Subject: AP1000 COL Standard Technical Report Submittal of APP-GW-GLR-127, Revision 1 (TR 127)

APP-GW-GLR-127, Revision 1

“PCS Tier 1 Diagram Correction”

## PCS Tier 1 Diagram Correction

#### **1. Figure 2.2.2-1**

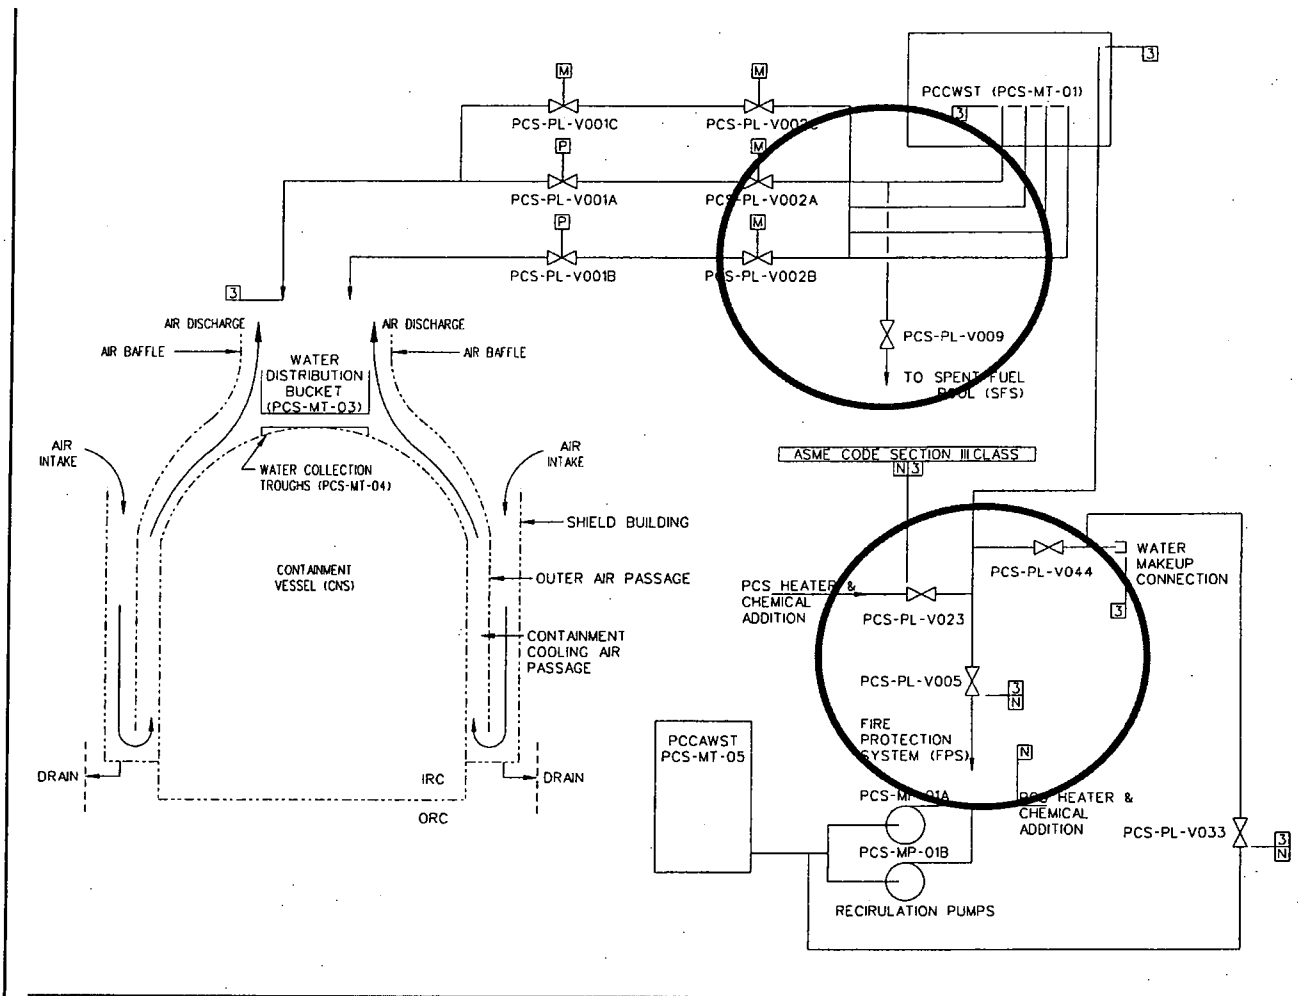
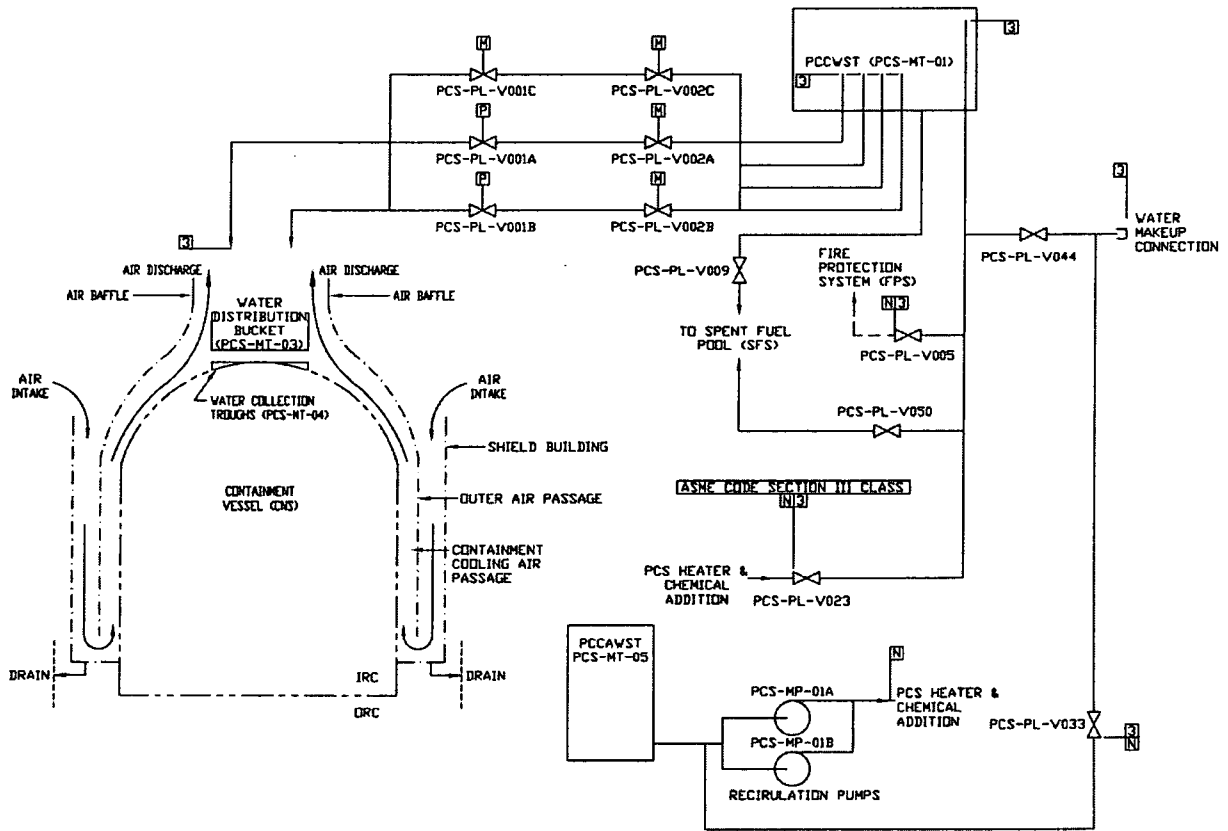
There were two design changes made to the PCS and/or its respective design documents that have an impact on Figure 2.2.2-1 in the Tier 1 information of the AP1000 Design Control Document (DCD). These changes are addressed in this technical report. There are three corrections made to the figure 2.2.2-1. They are as follows:

1. A National Academy of Sciences' report "Safety and Security of Commercial Spent Nuclear Fuel Storage: Public Report (2006)" expressed concerns about the ability of the spent fuel pool to be completely drained by a malicious act (beyond design basis accident). A design change was made to address this concern by providing a system with "spray" capability for the spent fuel. This capability uses either the passive containment cooling water storage tank inventory, or inventory from the fire protection system. Because of this change a line that used to branch off of a current PCS line was given its own penetration into the tank. The line leading from the PCCWST to the spent fuel pool (including valve V009) no longer branches off of the standpipe in the tank. This line now has its own connection into the tank.

2. A design change was made to the PCS Piping and Instrumentation Diagram (P&ID) to reflect the pipe routing that exists in the plant. This change modifies this figure to correctly depict the design of PCS. Downstream of the pumps, heater and chemical addition tank the connection to the Fire Protection System has been moved to reflect where it exists in the design. This was a correction that was made to the PCS P&ID to match the current design. Functionally, this change does not affect the design it only changes the location of a branch in that line.

3. Valve V050 is added to the Tier 1 diagram. This valve has always been present in the design. It is now included in the Tier 1 figure to address the following commitment made in the ITAACs, specifically Table 2.2.2-3 Design Commitment Number 8.b:

The PCS delivers water from the PCCAWST to the PCCWST and spent fuel pool simultaneously.
